## URBAN DESIGN PANEL

## RESPONSE TO URBAN DESIGN PANEL COMMENTS \_ ENTRANCE LOBBIES

**Re: Proposed Hotel, cnr Cambridge Terrace and Worcester Boulevard.**

RESPONSE TO URBAN DESIGN PANEL COMMENTS \_ HARLEY FACADE RETENTION OPTION A

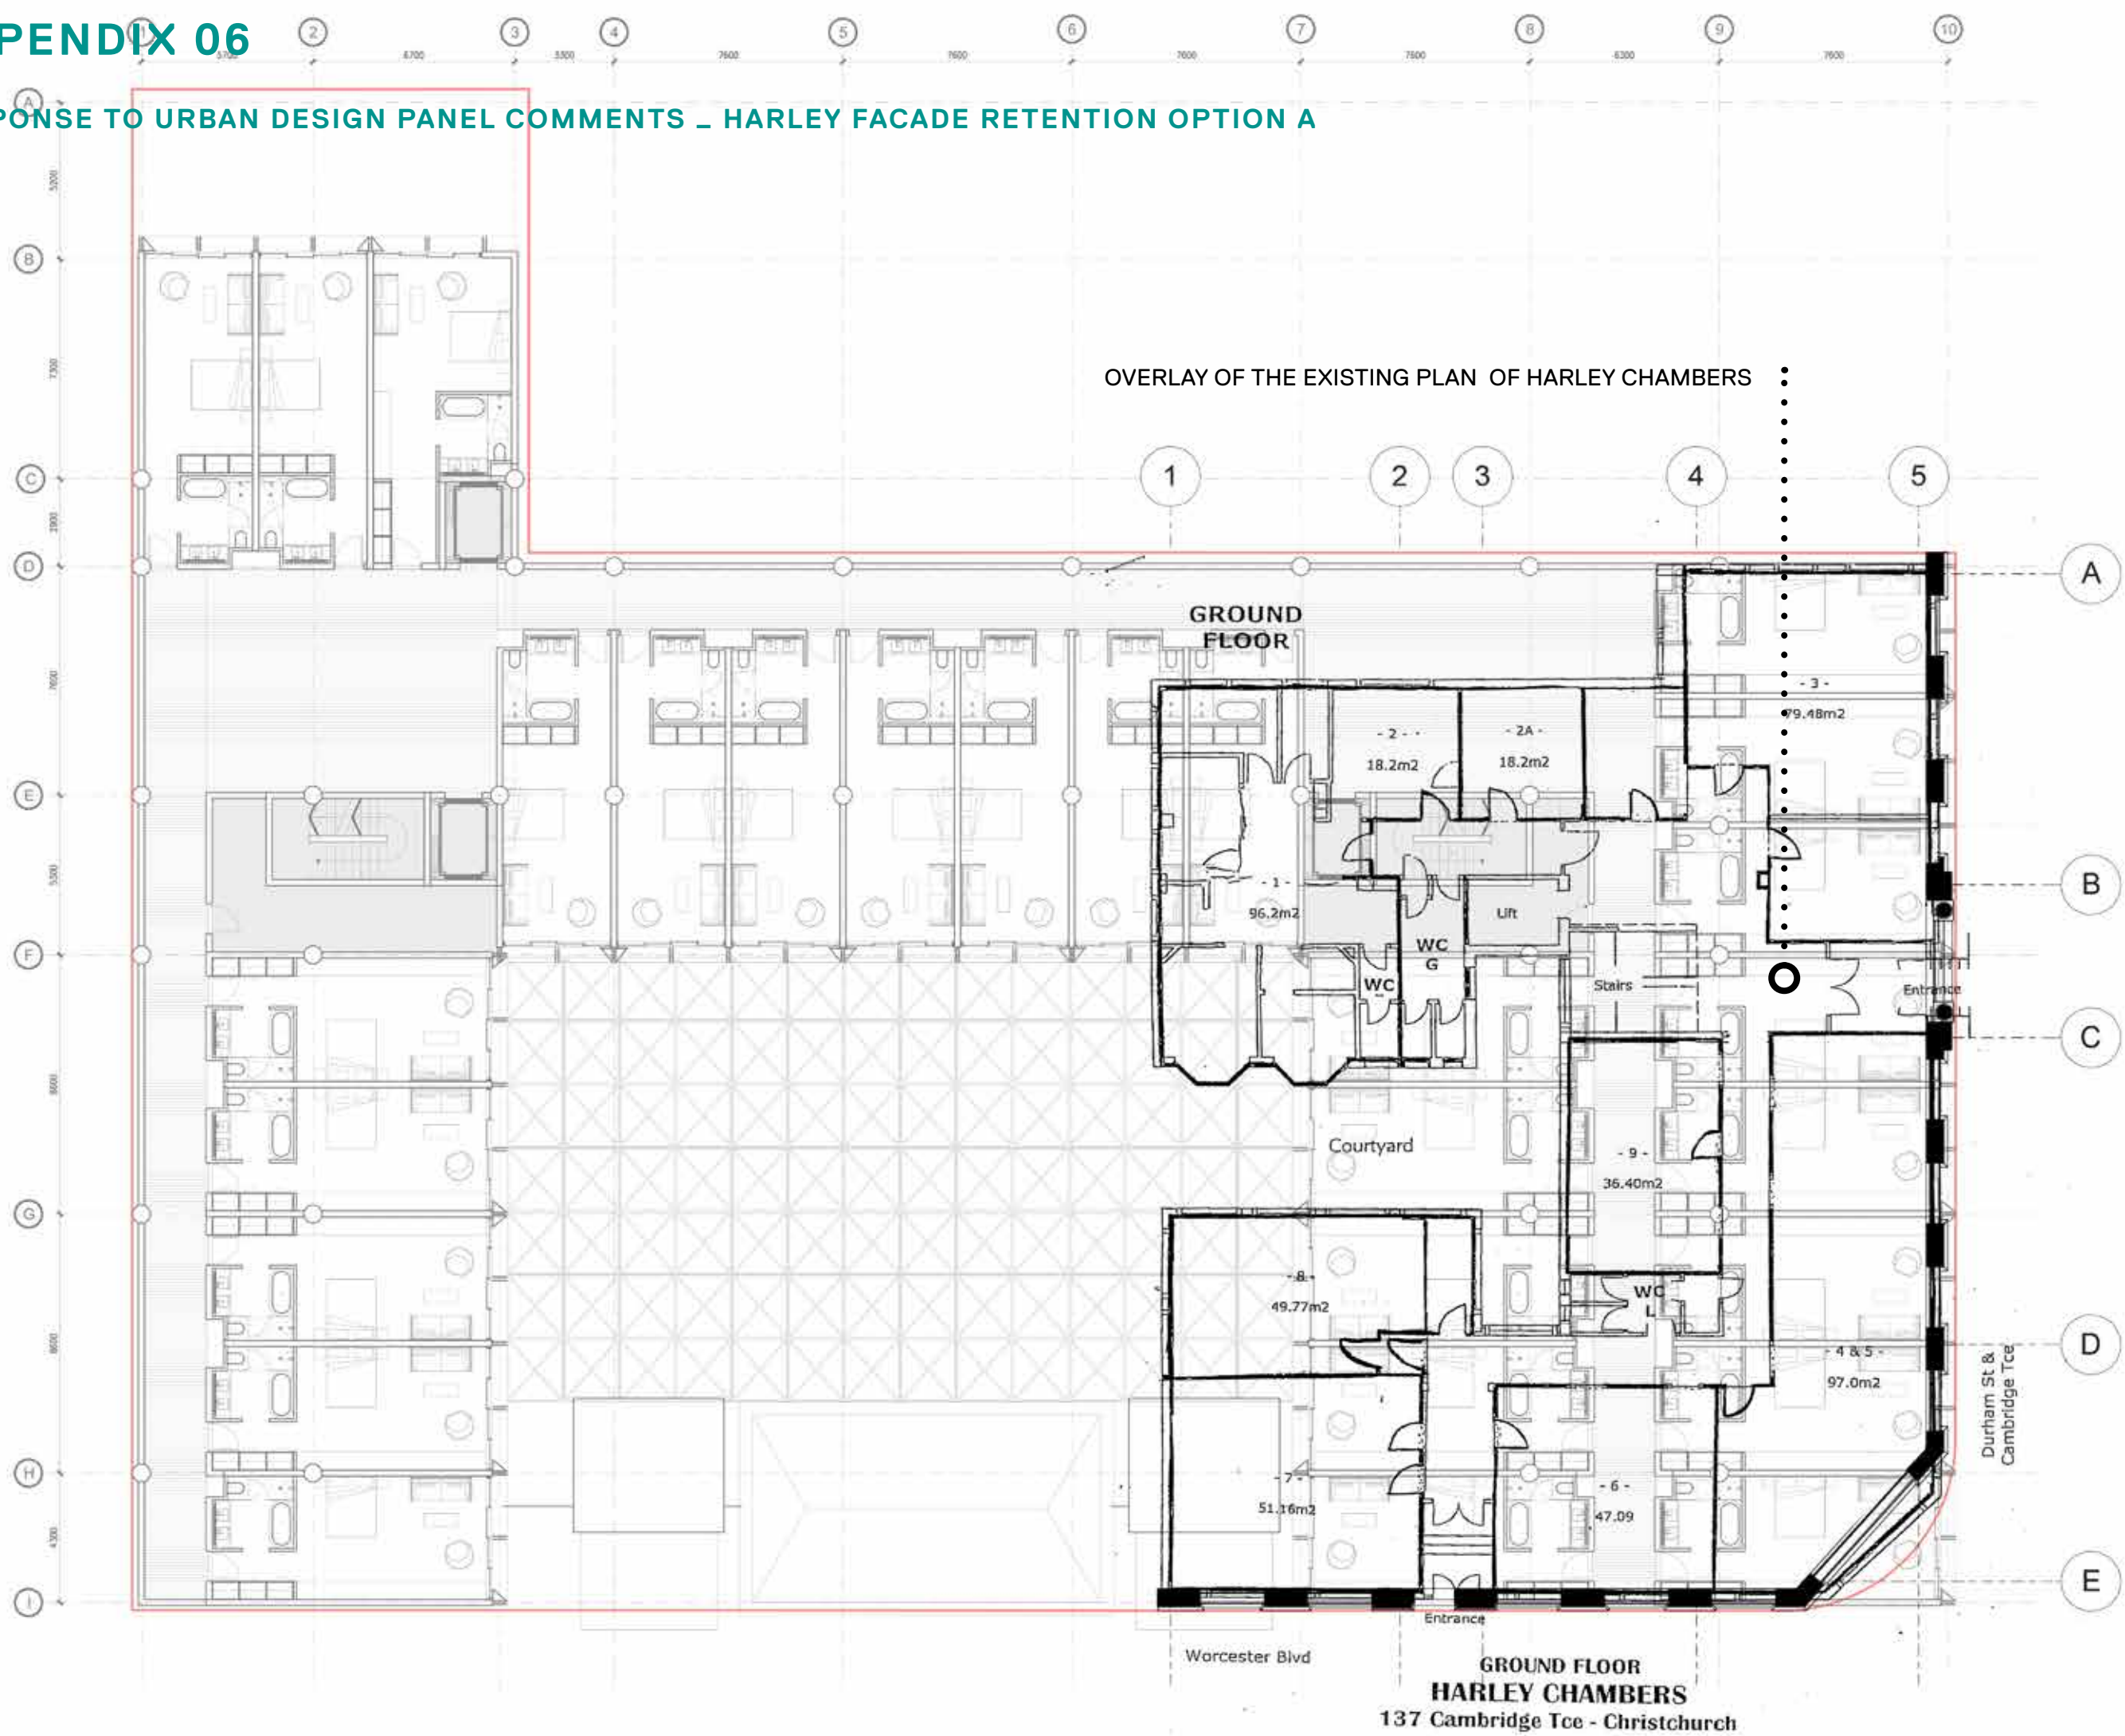
2. Considers that the corner treatment to the proposal needs further resolution to strengthen the relationship to the key axes and to this important pedestrian corner. Agreed
3. Acknowledge that a robust argument for the demolition of Harley Chambers will be required.

As the overlay drawing enclosed indicates, the idea of using the overall building is unlikely to be successful given the imperative to provide a certain number of rooms on the site.

If the floor layout was derived from the existing building layout, including the window/pier column relationship a number of rooms per floor would be lost from the layout.

A secondary concern would be that the floor to floor heights do not support the scale of rooms or difference in room scale required in the hotel design. The implied floor to floor heights are in the order of 3.5 m which are too small for the new structure and services which will be required.
